New bolt - tensioning pulley 531 0342 30

LuK AS Part No.: **531 0342 30**

Issued 12.2007

Fig. 3: LuK AS bolt

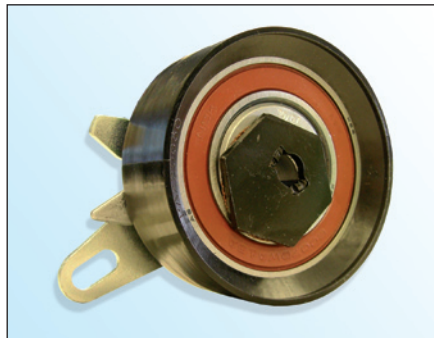
As part of the continuous development of our products and quality assurance, LuK AS now supplies a new bolt (**fig. 3**) with the tensioning pulley **531 0342 30**.

- flat bolt head with Torx
- Bolt head \varnothing 18.5 mm
- Bolt grade **10.9**
- Thread locking medium on the bolt
- Increased self-locking

LuK AS recommends replacing the original bolt (**Fig. 2**) with the supplied bolt.

Tightening torque: 20 ± 1,5 Nm
